CITY OF ALBUQUERQUE

Re: Enchantment Carpets
4815 Mcleod Rd. NE
Traffic Circulation Layout
Architect's Stamp **03-19-18** (F17-D099)

SITE PLAN

AS-1.0

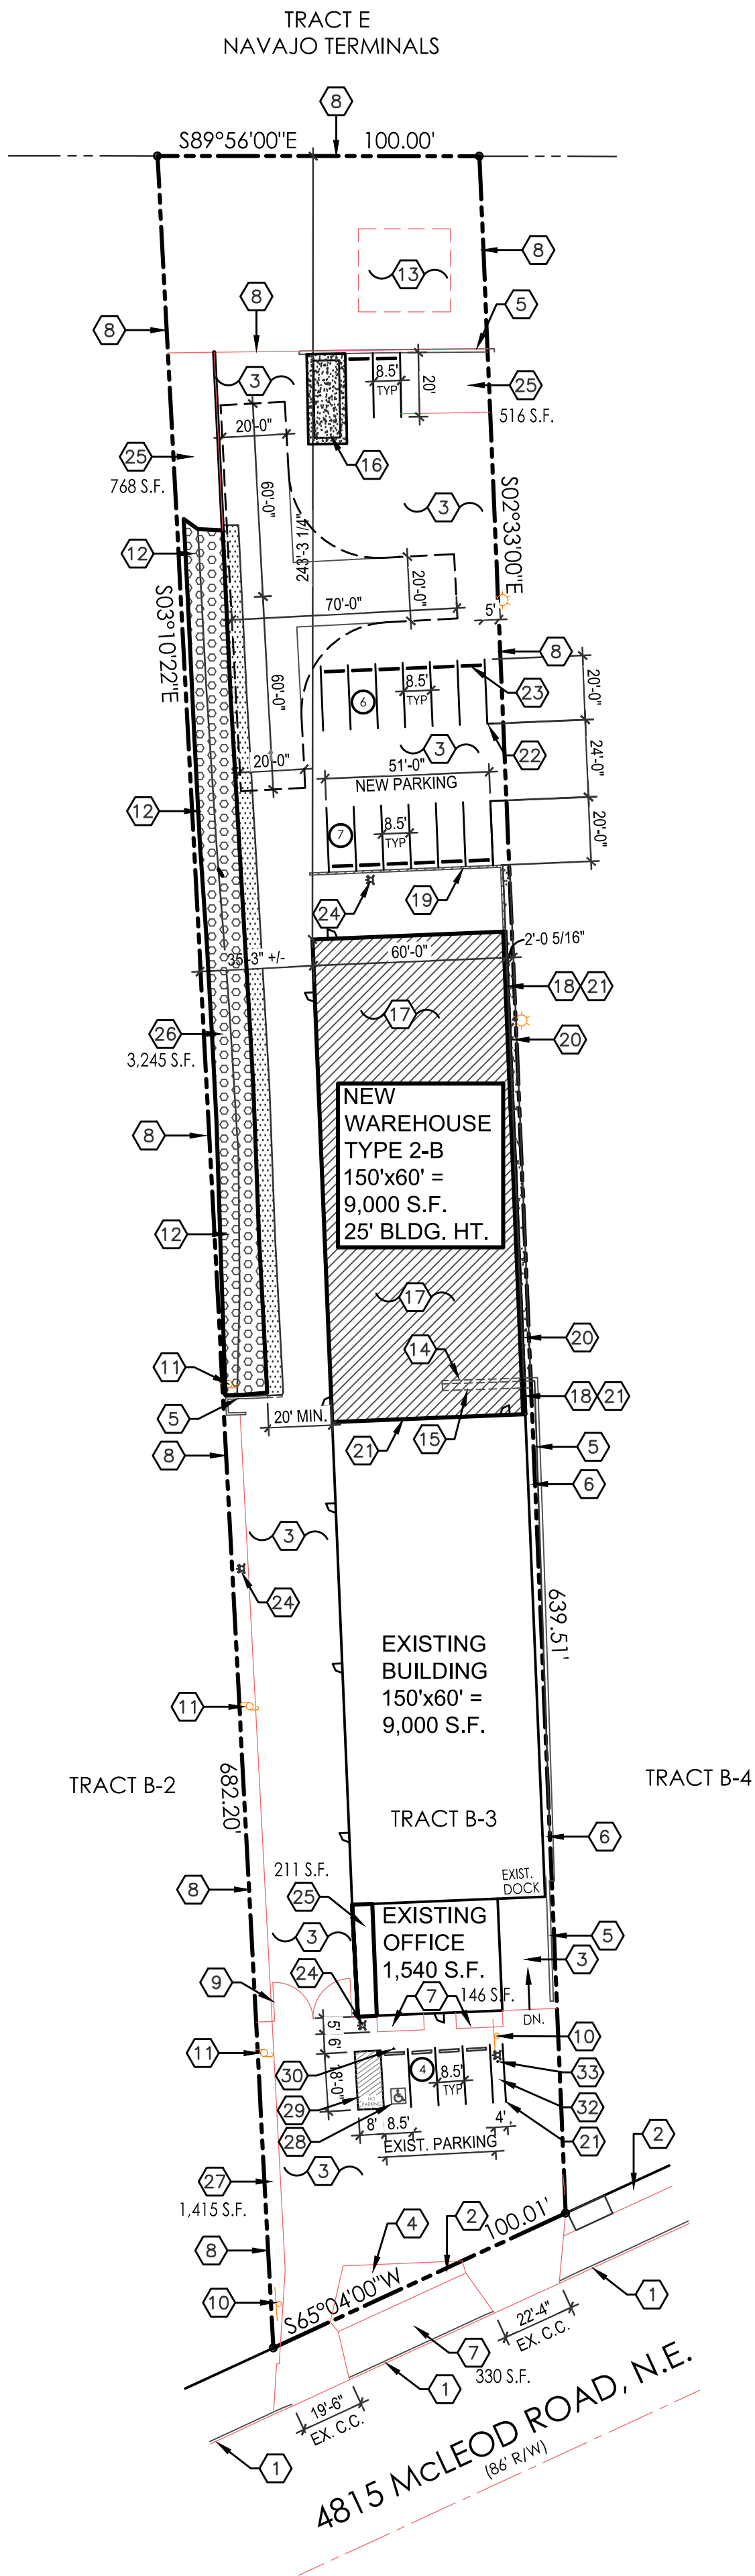
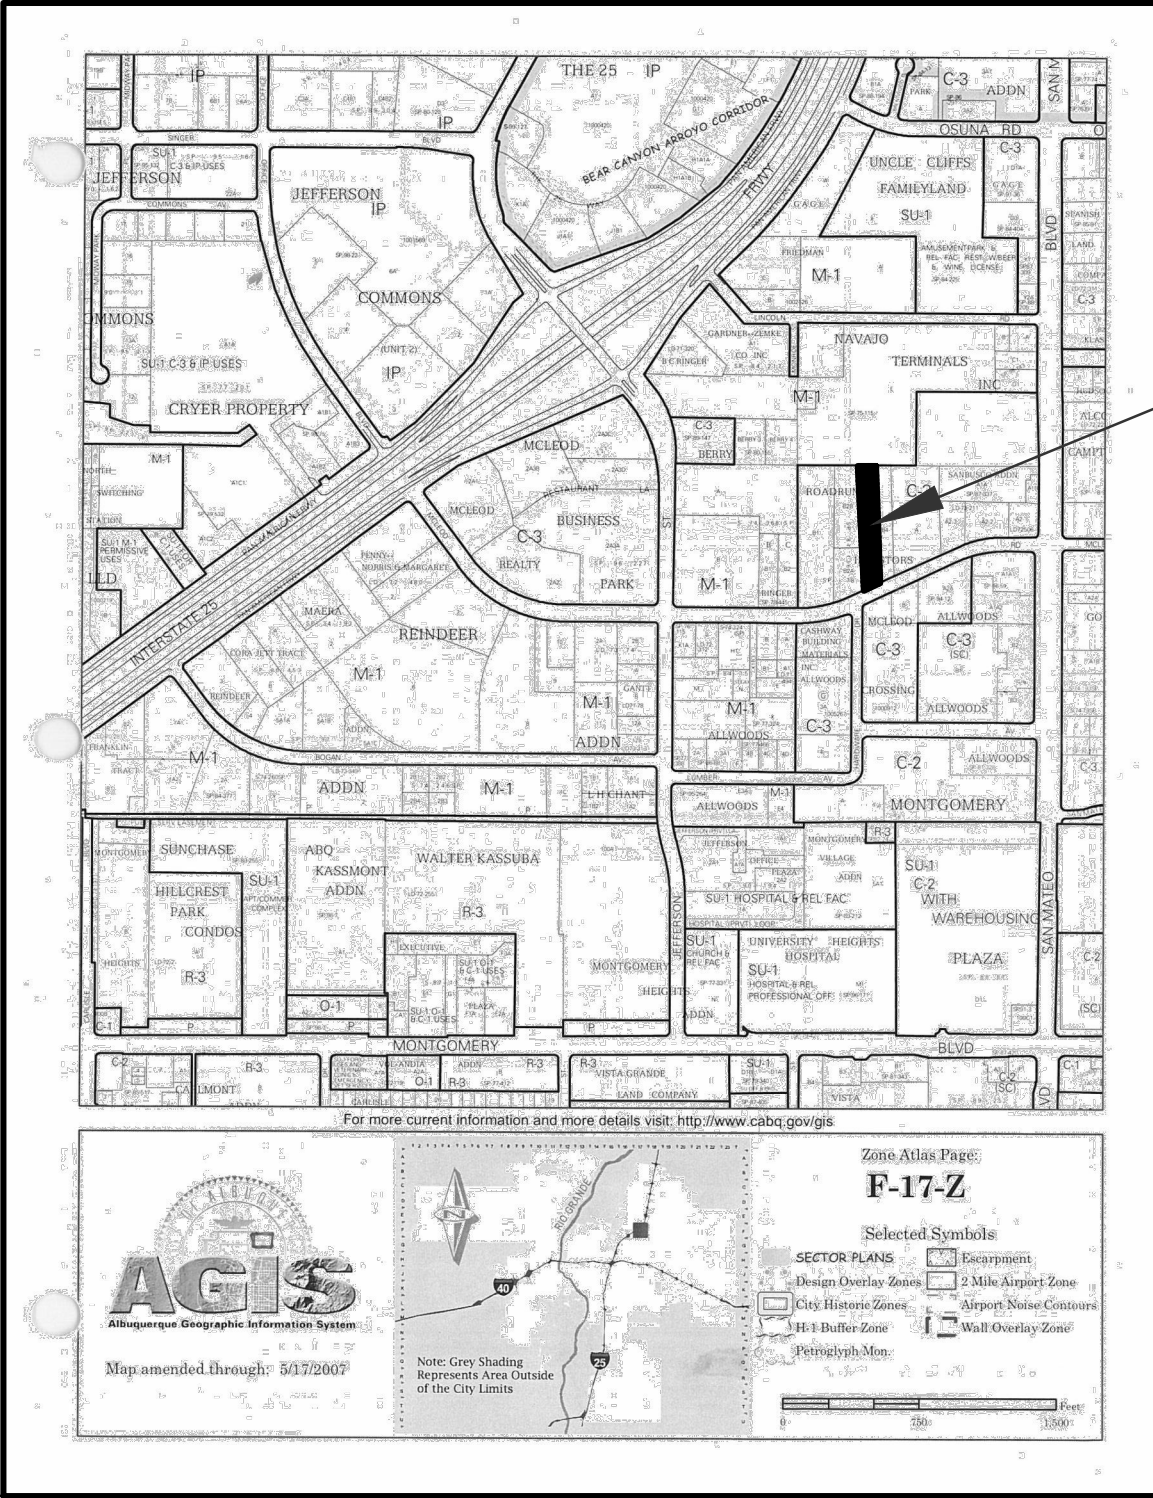
1. Service vehicle and/or refuse vehicle maneuvering must be contained on-site; provide a copy of refuse approval.
2. Please show the location of the bicycle rack.
3. Please provide a legend clarifying what the hatching locations indicate.
4. Provide slope information in the drainage feature. Do vehicles need to be protected from this area?
5. 24 feet is required for two-way vehicular traffic.
